# SERVICE LETTER

No. 833

Piper Aircraft Corporation

Subject: Cabin Pressurization System Rupture Disc Elimination

COVER PLATE DETAIL (P/N 48893-02)

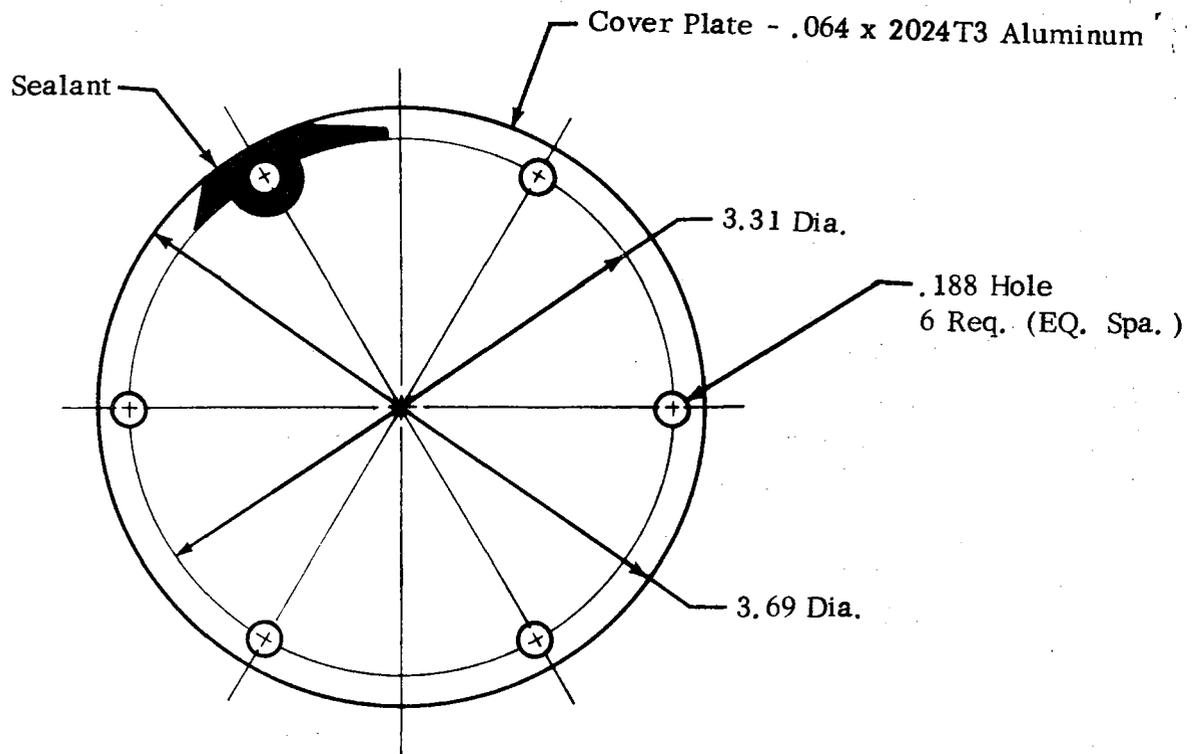
Purpose: The current cabin pressurization system on the above referenced models no longer requires the rupture disc assembly (formerly installed on rear of aft fuselage pressure bulkhead, sta. 274). Further, Rupture Disc Assembly, Piper Part Number 48683-00 is no longer supplied for field replacements through the factory Customer Service Sales Division.

This Service Release authorizes replacement of the Piper Part Number 48683-00 Rupture Disc Assembly (and related Placards, Piper Part Number 47582-00) with a cover plate that may either be fabricated locally or obtained through your Piper Field Service Facility. This product refinement announcement is intended to lower the operating cost of your Pressurized Navajo or Cheyenne cabin pressurization system by eliminating a redundant component.

1. Remove left access panel, located between sta. 274 and sta. 296, from aft fuselage.
2. Locate and remove the rupture disc assembly, installed on rear of sta. 274 pressure bulkhead, by removing the six screws and washers.

3. Remove the rupture disc placards from the forward and aft sides of the pressure bulkhead by drilling out the attachment rivets.
4. Fabricate cover plate per above detail or order plate from Piper Aircraft Corp. under part number 48893-02.

5. Clean cover plate and sta. 274 bulkhead, in the area where the rupture disc assy. and rupture disc placards were removed, with a non-corrosive solvent. Let dry.

6. Apply MIL-S-7502 Sealant (Products Research Comp. PRC-1221 or equivalent) around cover plate and around each hole, as shown on above detail, to make one continuous bead of sealant.

7. Install cover plate on sta. 274 bulkhead with the six screws and washers previously removed.
8. Apply sealant under head of MS20470AD3 rivets and install in rivet holes where placards were attached. (Note: Rivets need not be formed if sealant is allowed time to cure. Check cure time on sealant label.)

9. Reinstall left access panel to aft fuselage.
10. Make proper logbook entry of Service Letter compliance.
